## Administrative Action Administrative Site Review

**Case File / Name:** SR-89-16, TOURtech

**Request:** Development of a 1.61 acre recombined tract zoned IX-3 and SHOD-2 Overlay district into a 10,365 square foot 16.6' tall light industrial building.

## Engineering Services Design Adjustment – Staff Response

SR-89-16 Preliminary Site Plan

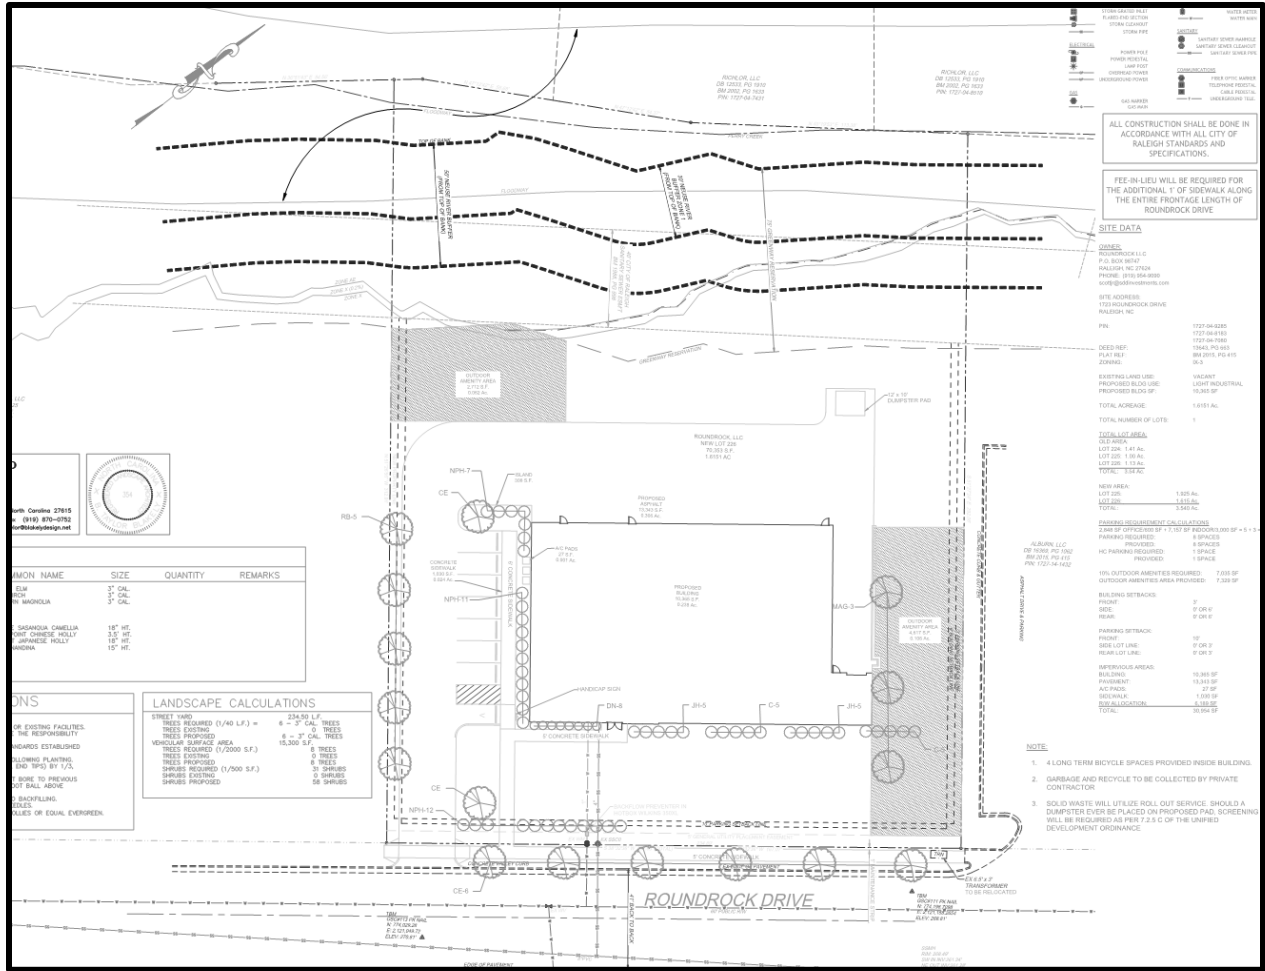
Staff is in approval of the design adjustment request due to the condition listed in the UDO 8.3.6.E.3, the site layout of developed properties. The applicant will not dedicate additional right-of-way. Sidewalks will be installed 3.5' behind the existing back of curb, and street trees will be planted within the 3.5' strip.

<p><b>Variances, Design Adjustments, Administrative Alternates:</b></p>	<p>Design Adjustment for Alternative streetscape cross section waiving the required Right of Way dedication, and allowing 3.5' planting strip from the back of curb to the sidewalk</p>	
<p><b>Other:</b></p>	<p>Parks and Recreation greenway reservation along Perry Creek extending 75' from stream top of bank, at the rear of the property.</p>

2. That a nitrogen offset payment must be made to a qualifying mitigation bank;
3. That a recombination map be recorded prior to or in conjunction with the recording of lots, recombining the existing lot into a single tract;

7. That A fee-in-lieu is to be paid for the additional 1' of sidewalk required along the entire frontage length of Roundrock Drive;
8. A tree impact permit will need to be obtained prior to issuance of building permits;

9. That in accordance with Part 10A Section 8.1.3, a surety equal to 125% of the cost of development related improvements, including 6 streetscape trees and a 5' width of sidewalk on Roundrock Drive is paid to the Public Works Department;
-
